MITSUBISHI ELECTRIC Inverter

No. 744E

Appearance Change for the FR-E800 Series Inverters

(Example) Appearance of the front cover

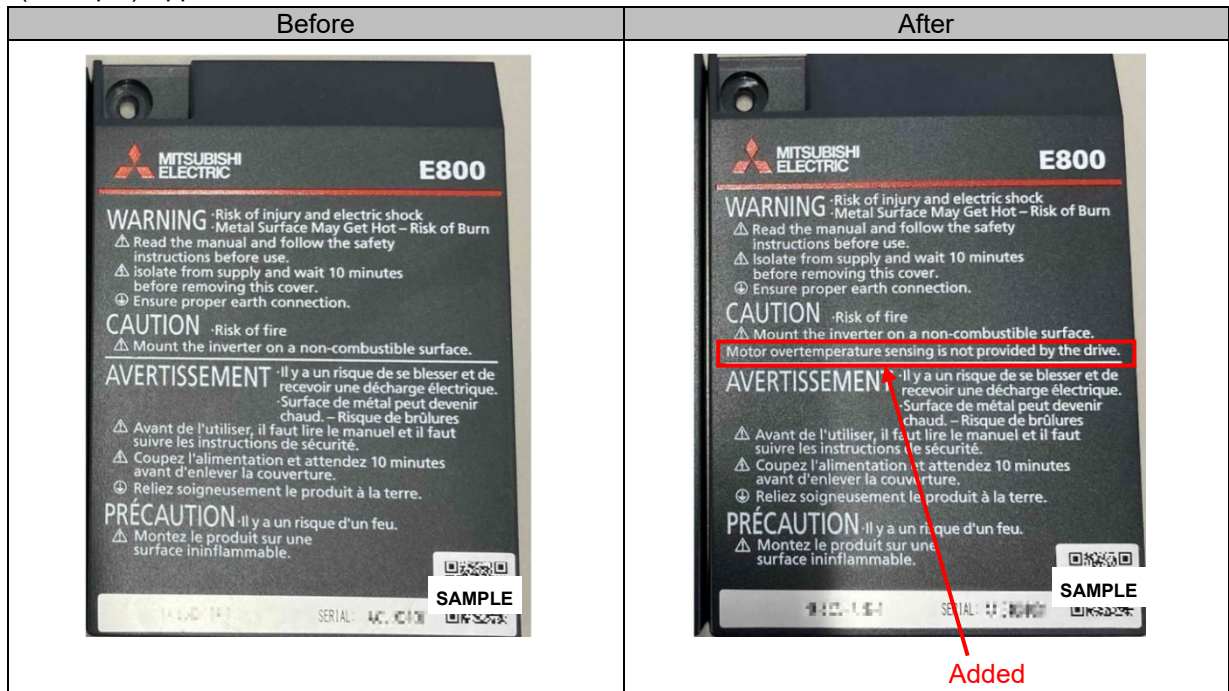
The indication enclosed in red will be added on the front cover of the inverter.
